## Determination 2014/048

# The refusal to issue a code compliance certificate for 10-year-old alterations and additions to a house at 19 Kellsmere Crescent, Island Bay, Wellington

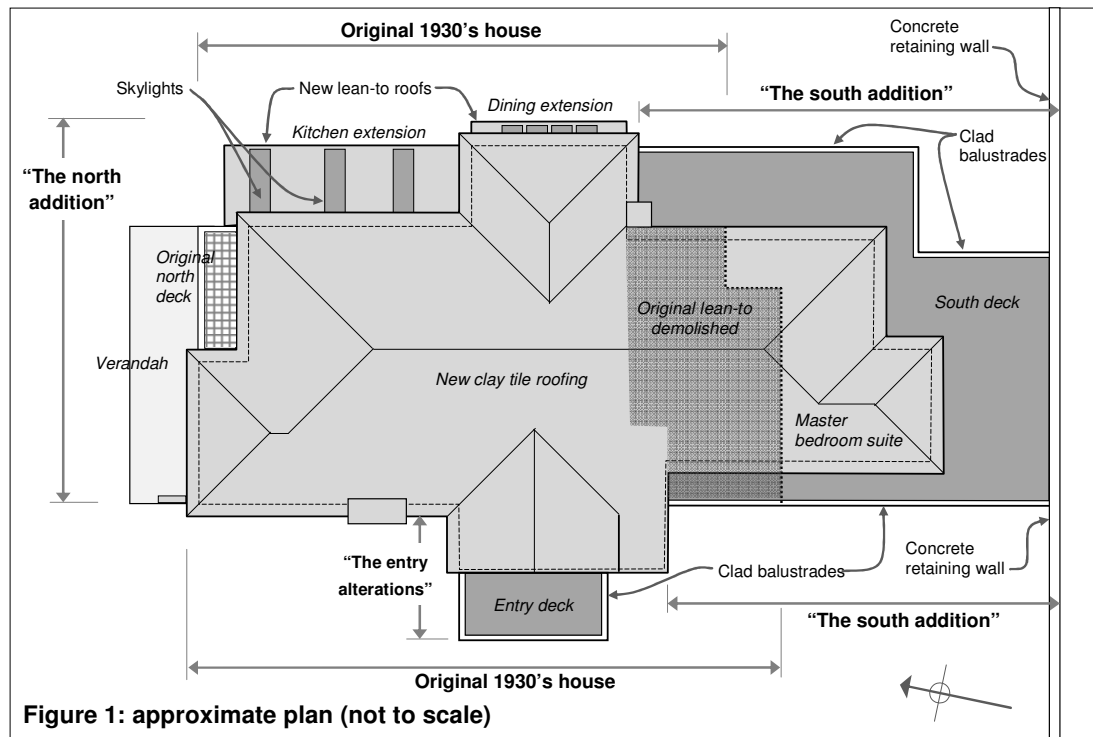
2.3.1 The subject alterations are shown in Figure 1 and included

- demolition of the original kitchen and laundry lean-to
- a large extension to the south (“the south addition”)

- alterations and additions to the north and east (“the north additions”)
- a minor addition at the main entry to the west (“the entry alterations”).
